Access Compliance Report

Public Rights-of-Way

(Curb Ramps)

Intersection ID: 9565	Main Street: N_TRYON_ST	Cross Street: W_32ND_ST	Location: NE
ADA ID: 4C54B04C324D	Ramp Type: PerpDiag	Initial Pass/Fail: Fail	Overall Compliance: No
Severity Score: 35			
Codes/Mitigation Info/Possible Solution		Field Measurements/Component Compliance

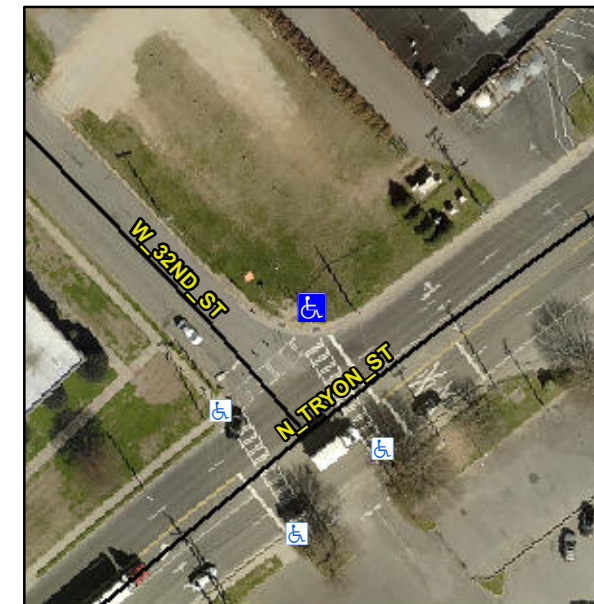
R304.5.1, R304.2.2

Compliance	Description	Data	Compliance	Description	Data
N/A	Ramp Length (in)	56.5	No	Ramp Slope (%)	12.5
No	Ramp Width (in)	40.5	Yes	Ramp XSlope (%)	2.1
N/A	Flare Type LT	N/A	N/A	Flare Type RT	N/A
N/A	Flare Slope LT (%)	N/A	N/A	Flare Slope RT (%)	N/A
N/A	Flare Traversable LT?	N/A	N/A	Flare Traversable RT?	N/A
N/A	Landing Length (in)	N/A	N/A	DWS Provided?	N/A
N/A	Landing Width (in)	N/A	N/A	DWS Contrast?	N/A
N/A	Landing Slope (%)	N/A	N/A	DWS Length (in)	N/A
N/A	Landing X Slope (%)	N/A	N/A	DWS Full Width?	N/A
N/A	Landing Curb? (Y/N)	N/A	N/A	DWS Offset (in)	N/A
N/A	Shared Landing?	N/A			
N/A	Gutter Ponding?	N/A	N/A	Gutter Slope (%)	N/A
N/A	Gutter Lip Ht (in)	1.0	N/A	Gutter X Slope (%)	N/A
N/A	Painted X Walk1?	Yes	N/A	Painted X Walk2?	Yes
	X Walk 1 Direction	To SW		X Walk 2 Direction	To SE
N/A	X Walk 1 Width (in)	106.0	N/A	X Walk 2 Width (in)	112.0
	X Walk 1 Slope (%)	1.6		X Walk 2 Slope (%)	0.1
	X Walk 1 X Slope (%)	1.4		X Walk 2 X Slope (%)	3.1

Remove & Replace Curb Ramp With Two New Directional Ramps or Equivalent.
